CITY OF ALBANY
Public Works Department

ADDENDUM #1

WL-18-02
PINE MEADOWS WATER LINE REPLACEMENT

SHEET NO. 7 OF 11
 PROJECT NO: WL-18-02
 FILE: BASE.DWG

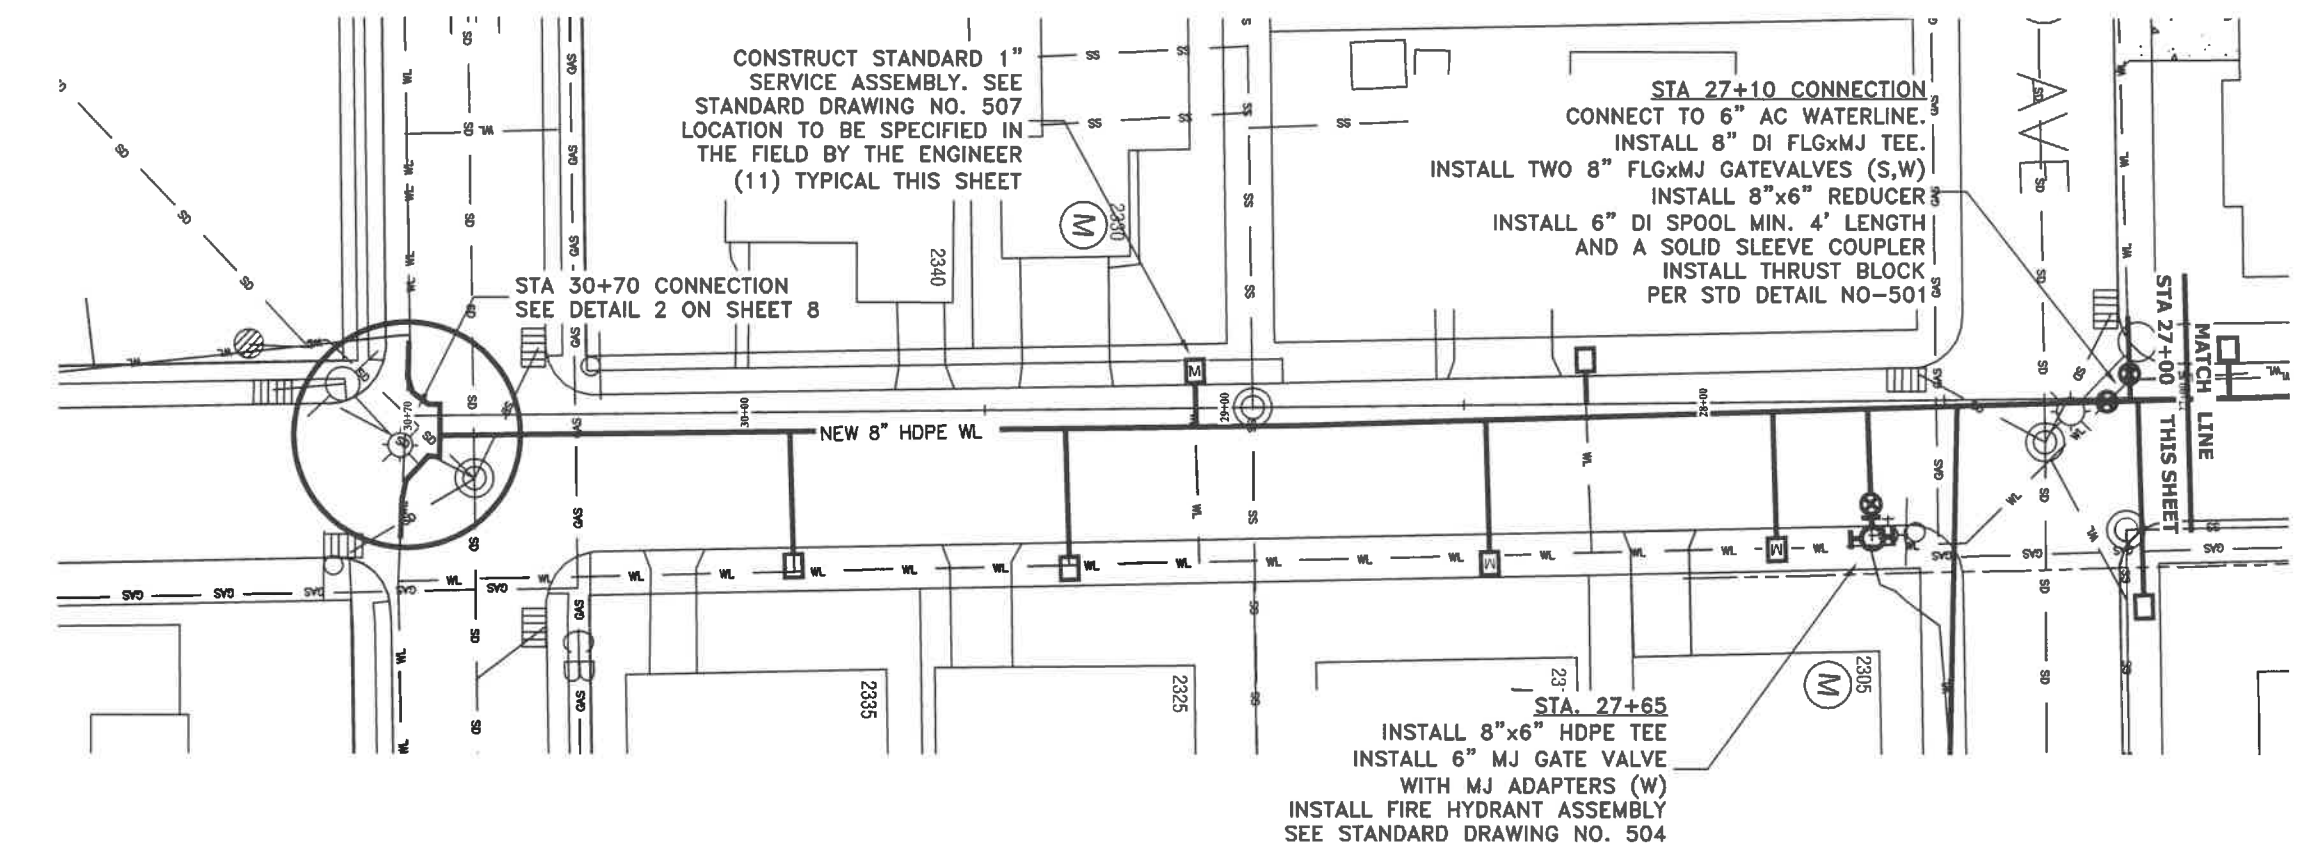
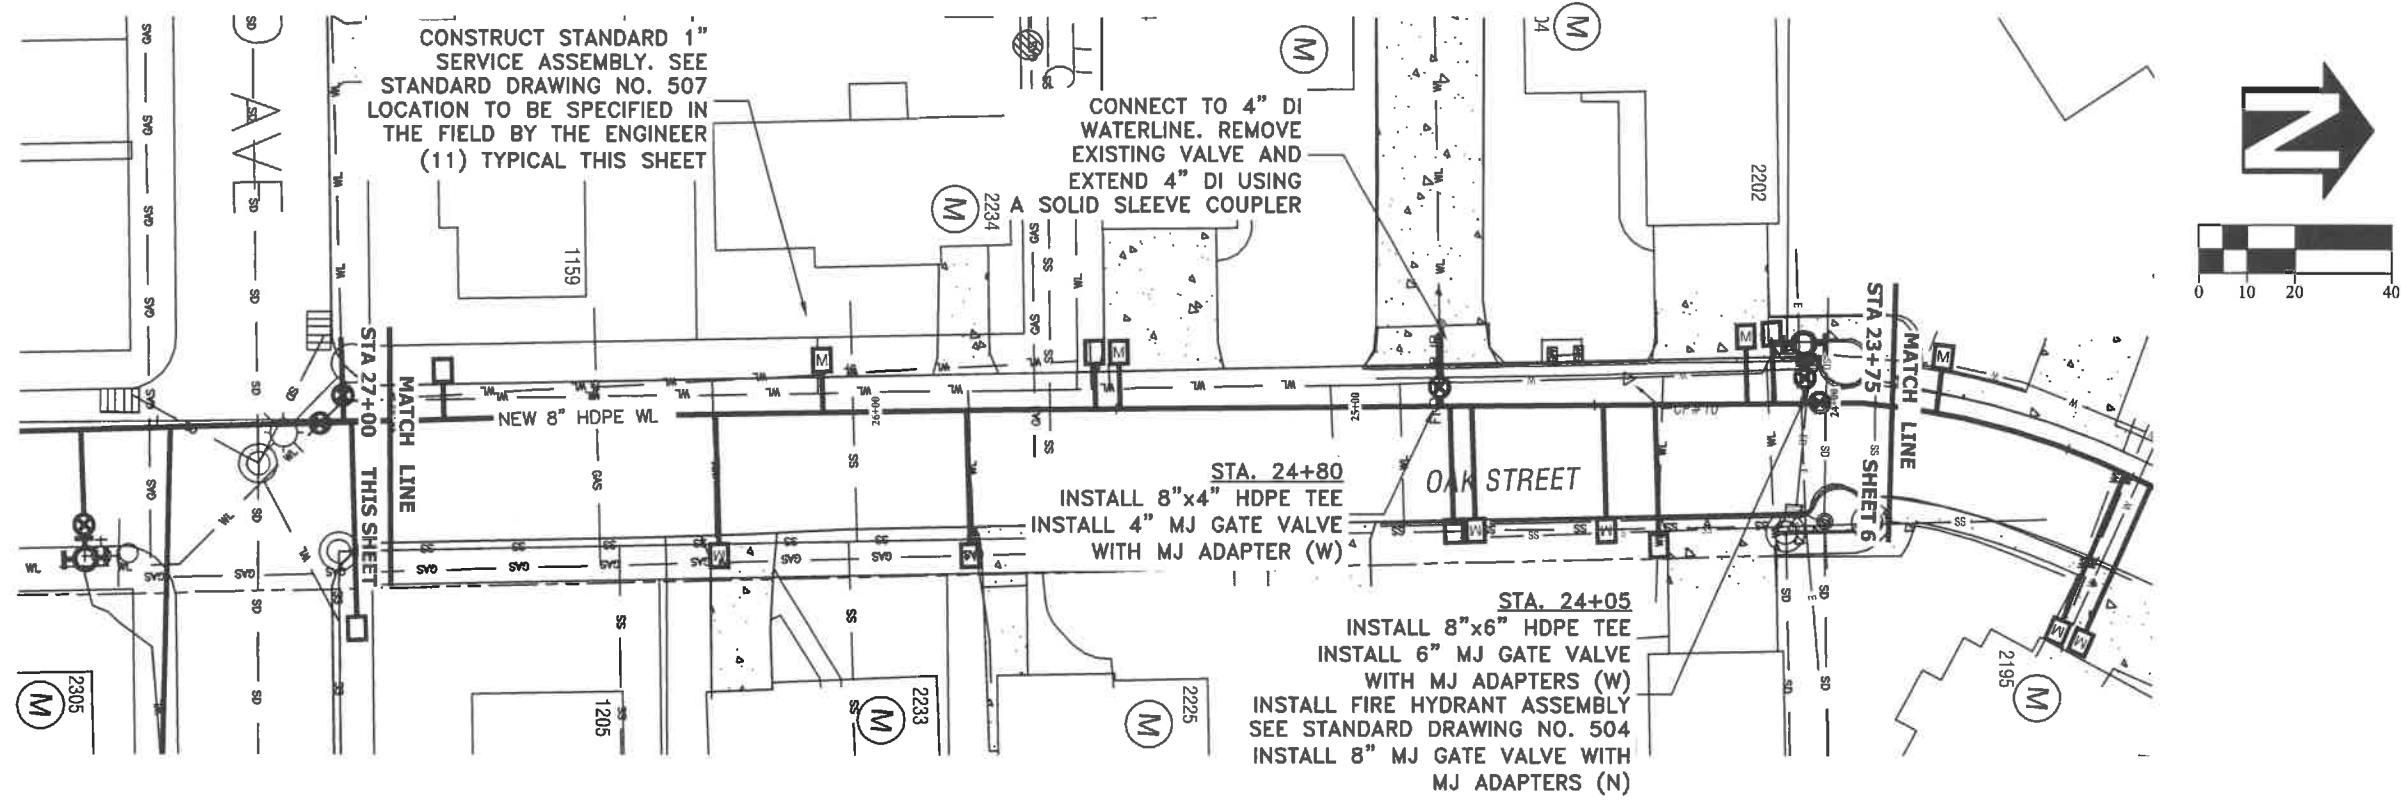
Sheets 2 and 7 are being replaced in the Construction Drawings.
